# AIA® Document G701® – 2017

## Change Order

<b>PROJECT:</b> <i>(Name and address)</i> Softball Complex Sulphur Springs Park Madison County, Mississippi	<b>CONTRACT INFORMATION:</b> Contract For: General Construction Date: 06 May 2024	<b>CHANGE ORDER INFORMATION:</b> Change Order Number: 003 Date: 16 June 2025
<b>OWNER:</b> <i>(Name and address)</i> Madison County Board of Supervisors 146 W. Center St., Canton, MS	<b>ARCHITECT:</b> <i>(Name and address)</i> JH&H Architects Planners Interiors PA 1047 N. Flowood Dr., Flowood, MS	<b>CONTRACTOR:</b> <i>(Name and address)</i> England Enterprises, Inc. 8295 Wildwood Rd., Vaughan, MS

Re: 21-027B Softball Complex, Sulphur Springs Park  
**Proposed Change Request 8:**  
Slope, tree removal, silt fence to improve drainage **\$5,920.41 plus 10 days**

**C304**

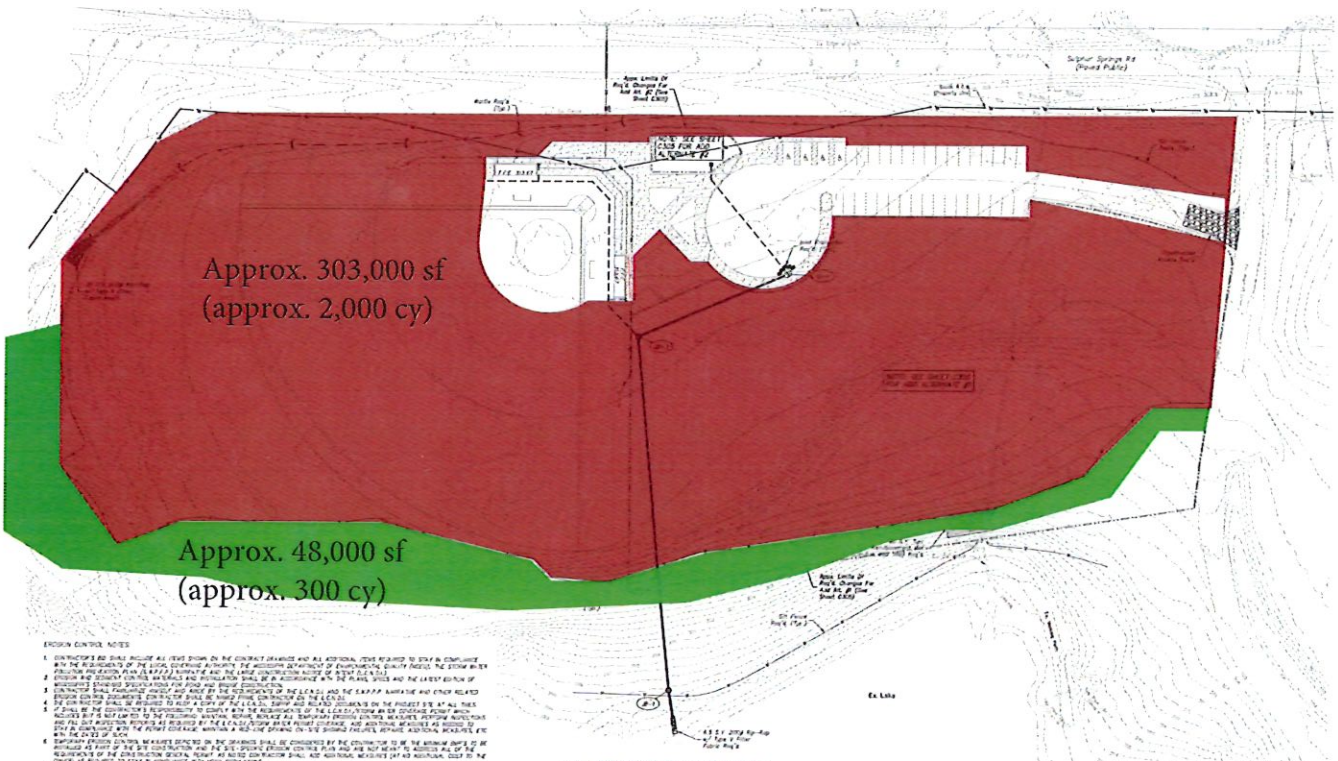
Required topsoil over the 2,000cy noted above, will be placed for \$60/CY (contract unit cost). This cost covers the cost of the topsoil, hauling and placing the topsoil over and above the contract limits added by PCR 8 for slope improvements. We estimate 300 cubic yards of topsoil will be required at an additional cost of **\$18,000**. As this is a unit cost, no markup is allowed.

Attachments  
S & S Topsoil pricing  
Site drawing indicating topsoil locations
